## Response to Q211873 Additional Information Letter

All text in bold are from the Q211873 AI letter followed by Openwater's response.

*Figure S-2: Example of the proposed Openwater Headset, recorded on a normal control subject*

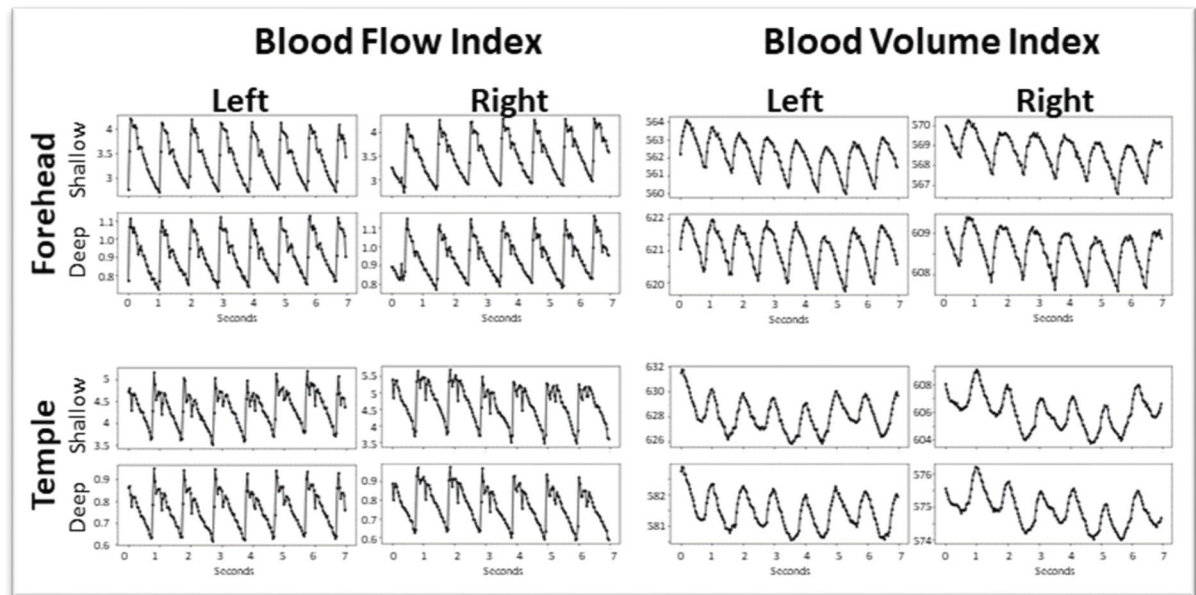
*Additionally, as mentioned in section 2.3 of the submission, various parameters are displayed after the completion of the scan by the Openwater Headset. From this information, it is not clear if the data can be independently interpreted by the clinical user or if it requires software analysis for utilization, and whether there is basic software included for use of the Openwater Headset that is separate from the Openwater LVO Stroke Alert software. To facilitate the understanding of the type of information that will be available to clinical users to inform their assessment of patients suspected of having a large vessel occlusion (LVO), provide complete descriptions of the outputs of both the Openwater Headset and the Openwater LVO Stroke Alert software, accompanied by a discussion of how you intend for these device outputs to be clinically interpreted in the assessment of patients suspected of having a LVO.*

Figure S-2 shows an example of the proposed output of Openwater Headset. Note that the BFI and BVI information shown in the example below were measured by placing the Openwater wand prototype at the forehead and the temple location of a healthy control. With the Openwater Headset wearable form factor, such repeated placement would not be necessary.

Openwater believes that these outputs have inherent interpretive value and can be independently used by the clinical user when displayed as part of the Openwater Headset operation. Of note, CBF and CBV measurements are key parameters through which MR and CT perfusion scans provide data to clinicians during standard-of-care in-hospital work-up of stroke patients, and therefore these outputs may be similarly interpreted by clinicians when measured at the point-of-care using the headset device in clinical research settings. However, since the efficacy of these measurements have not been noted in disease states, Openwater proposed restrictions on the use of these measurements within the proposed Indications for Use, specifically, for use only in research settings. The evolution of Openwater Headset's indications beyond the one noted in Q211873 was seen by Openwater as beyond the scope of the breakthrough designation request and focused the submission on only on the capabilities of the proposed Openwater Headset to support the Openwater LVO Stroke Alert.

*Figure S-4: Block diagram showing Openwater Headset with Openwater LVO Alert installed as a package or module*

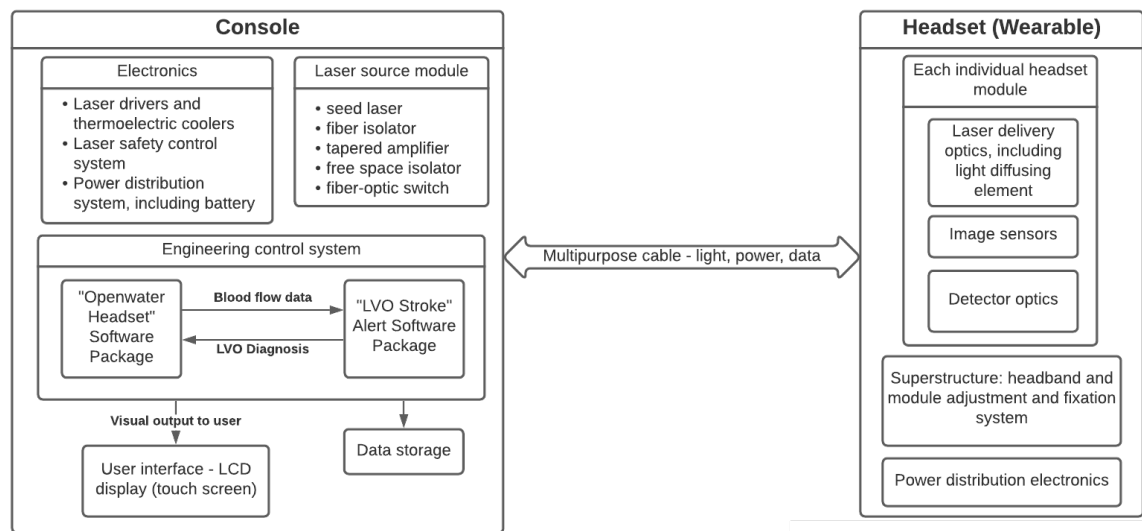
- b. ***Section 2 of the submission contains information related to the device description for the Openwater Headset and the Openwater LVO Stroke Alert. However, from the information described in subsections 2.2 and 2.3, it is not clear how the Openwater Headset interfaces with the console and the Openwater LVO Stroke Alert to generate a notification and communicate that an LVO is suspected. Clarify how the information is transmitted from the Openwater Headset to the console and then to the Openwater LVO Stroke Alert for analysis of the data obtained from the Openwater Headset. In your response, also identify potential sources of device failure, including alert failure, associated with wireless or cellular connections related to data transmission.***

The Openwater LVO Stroke alert is a software package that can be installed within the Openwater Headset's console. This package uses the Openwater Headset generated blood flow data to analyze the likelihood of an LVO. A block diagram of the various elements of Openwater Headset including Openwater LVO Alert is shown in Figure S-4. As shown in the figure, the two devices are located in the shared platform of the Openwater Headset console and the interface between the two devices is in software only. When the Openwater LVO Stroke Alert software package is installed, the Openwater Headset automatically shares the recorded blood flow data with Openwater LVO Stroke Alert and the subsequent LVO stroke alert finding will be displayed on the LCD screen of the console. There are no wireless or cellular paths of transmission for the data and all of the data is transmitted through physically wired means.

Table S-1: Sources of variability and their mitigations

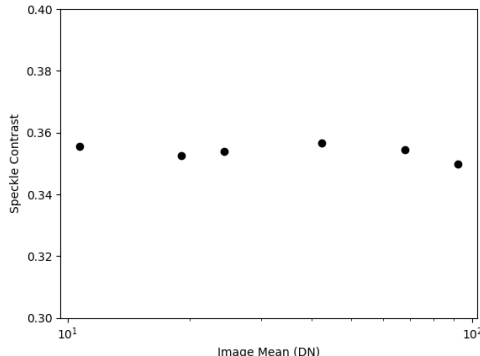
***affected by various patient- specific characteristics across the intended patient population, such as skin pigmentation, size of forehead, hair length, and level of consciousness. Provide a discussion of these types of patient- specific factors, how these factors may affect device performance, and whether any mitigations have been applied to the design or envisioned device use to ensure adequate performance for the intended patient population. Also, evaluate whether there are other relevant factors related to expected use of the device once in clinical practice (e.g., from the intended use environment, sources of variability in the clinical user experience) that may affect its performance.***

Source of variability	Discussion/Mitigations														
Skin tone	<p>Skin tone should have minimal effect on Openwater LVO Alert's algorithms for various reasons:</p> <ul style="list-style-type: none"> <li>• The algorithms operate by comparing inpatient measurements. Specifically it compares relative differences between measurements of the left and right hemispheres of the same individual. Physiological differences which contribute to interpatient variability are not expected to influence these inpatient hemispheric comparisons.</li> <li>• The first step in calculating the blood flow index by Openwater Headset is to calculate the speckle contrast. The speckle contrast is calculated by dividing the standard deviation of pixel values on the image sensor by the mean value of the pixels. If the amount of light hitting the sensor changes by some fraction (e.g. due to increased absorption of the light by the skin), both the standard deviation and the mean have the same relative change, and their quotient (i.e. the contrast), does not change.</li> </ul> <p>In an experiment to simulate the effect of a thin absorbing layer, Openwater performed the following experiment: a variable neutral density filter was used to reduce the amount of detected light over a 10x range when measuring a tissue simulating phantom. As can be seen in the figure below, standard deviation of the speckle contrast values is less than 0.6% of the mean over the entire range of intensities</p>

Figure S-5: Analysis by Openwater LVO Stroke Alert compared to standard of care CT and MR

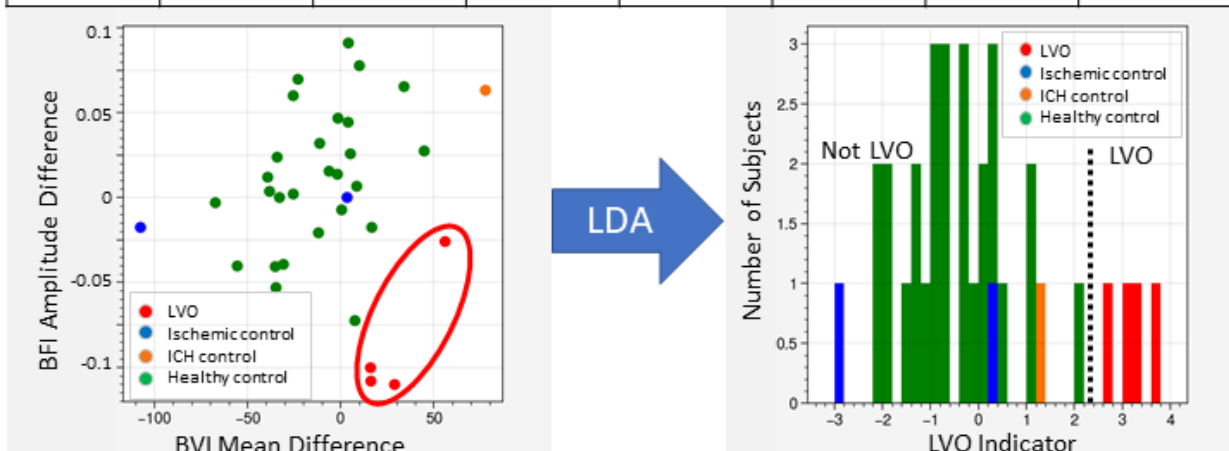
- a. ***Section 1 of the submission provides information discussing the benefits of a pre-hospital LVO stroke alert in improving clinical outcomes. Additionally, ambulances outfitted with computed tomography (CT) scanners are mentioned as an alternative to the proposed device. However, the submission does not contain any discussion or provide data to show how the preliminary performance of the Openwater LVO Stroke Alert software algorithm and Openwater Headset compares to the performance of CT scans conducted in ambulances or to other existing methods of evaluating these patients in the pre-hospital setting, such as various validated stroke scales, or how the subject device compares to existing methods of diagnosis of stroke in the hospital setting. Therefore, provide performance data to demonstrate that the speed, safety, sensitivity, and specificity of the subject device is better than available alternative methods of assessment and diagnosis of stroke patients with an LVO (i.e., confirmed presence or absence of an LVO based on computed tomography angiography (CTA) scans or other types of imaging modalities). This preliminary evidence should demonstrate the ability of the subject device to distinguish between hemorrhagic and ischemic strokes as well as other neurological conditions which may present with overlapping symptoms as suspected strokes.***

To demonstrate the preliminary evidence of the efficacy of Openwater LVO Stroke Alert, a more detailed analysis of the clinical data compared to CT and MRI scans is presented in Figure S-5. This analysis includes additional clinical data acquired in Openwater's human LVO feasibility studies since the Q211873 submission. The figure displays the standard of care CT and MR imaging as well as Openwater data on patients with LVO strokes and non-LVO strokes. The figure includes the salient CT and MR slices, salient BVI and BFI measurements from these patients, and the classification results by Openwater LVO Stroke Alert. As shown in the figure, the Openwater device classified 100% of the LVO strokes accurately (N=4), classified 100% all the non-LVO strokes as such (N=3, with one ICH and two non LVO ischemia), and 100% of the controls (N=30) as not LVO. While the algorithm utilizes several features and is in continued development, the bottom of Figure S-5 shows the key factors utilized in the classification that demonstrates good specificity of the features.

Though this analysis is based on a small sample size, Openwater believes that with the bench data noted above and the preliminary human clinical evidence shown in Figure S-5, there is strong preliminary evidence that demonstrate the ability of the subject device to distinguish between LVO strokes, hemorrhagic strokes, other non-LVO ischemic
